## STAFF REPORT

**AGENDA ITEM:** Hidden Meadows 2<sup>nd</sup> Addition OP Final Plat

Re: Hidden Meadows 2nd Addition  
Final Plat/Construction Plan  
Completeness Review

HIDDEN MEADOWS OF LAKE ELMO  
SITE DEVELOPMENT PLAN  
DEVELOPMENT PLAN

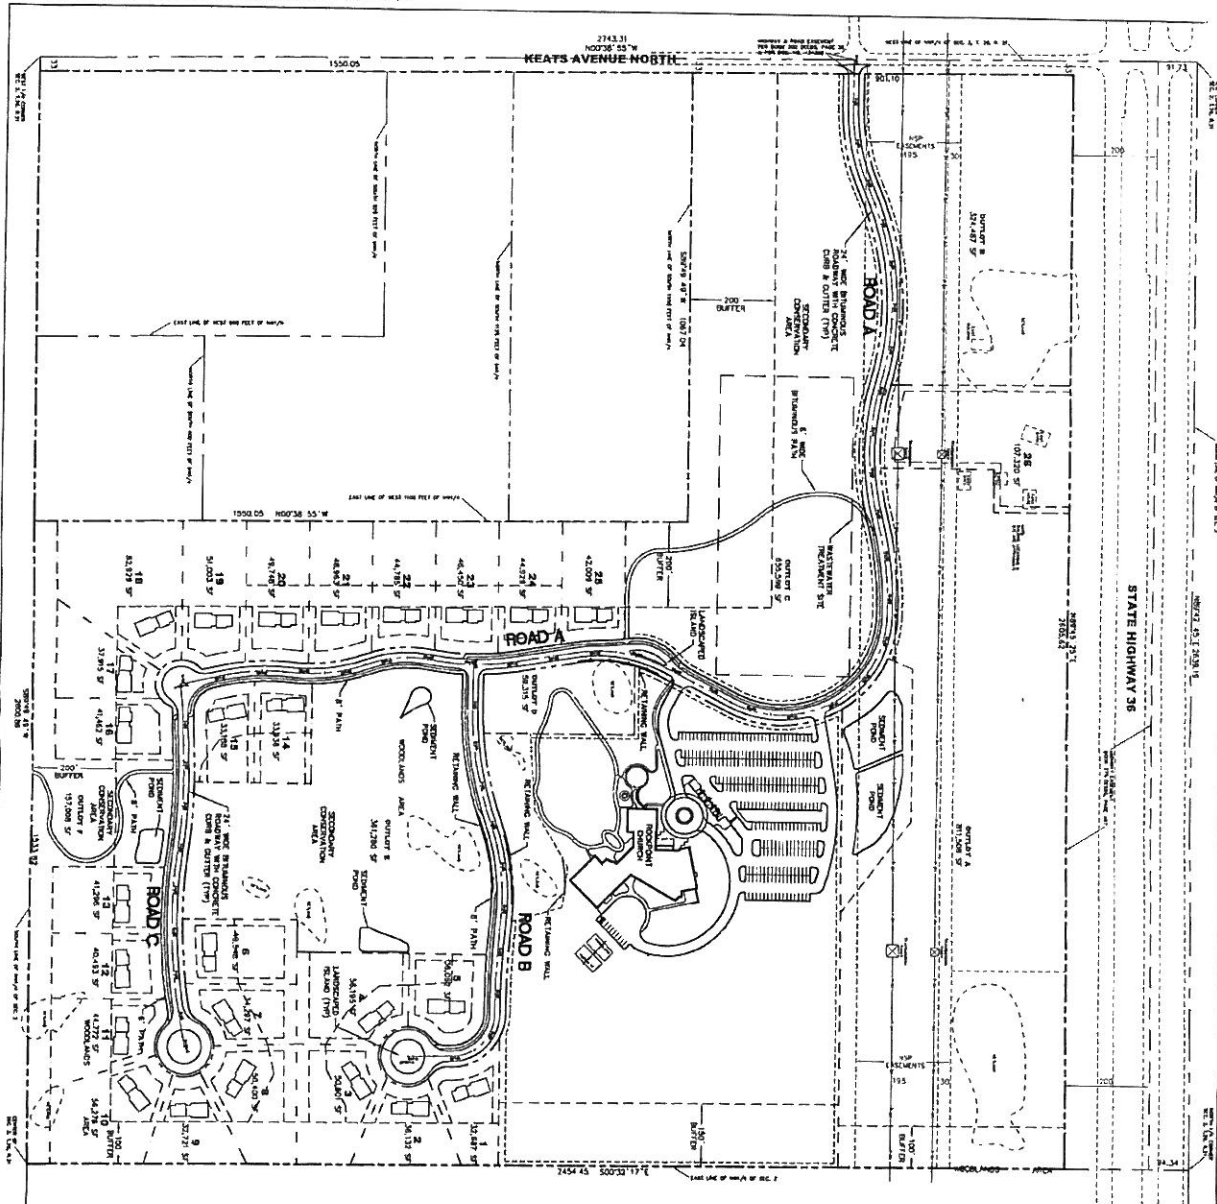
7. Please identify the seeding areas (limits of native seeding) for each proposed seed mix on the plans or a separate plan exhibit.
8. Reading through the preliminary plat approval records, there are a number of comments about the effectiveness of screening on the east side of the plat. I found the Kimley-Horn Landscape Plan dated 05/02/2006 that show a staggered row of conifers along the east

tree-line intended to bolster the screening. This planting was subject of much debate and it appears as though a final landscape plan was approved prior to the July 5, 2006 City Council meeting. I would suggest this was the approved landscape plan. If so, your plans are deficient screening along the east in particular (see attached 05/02/2006 Landscape Plans)
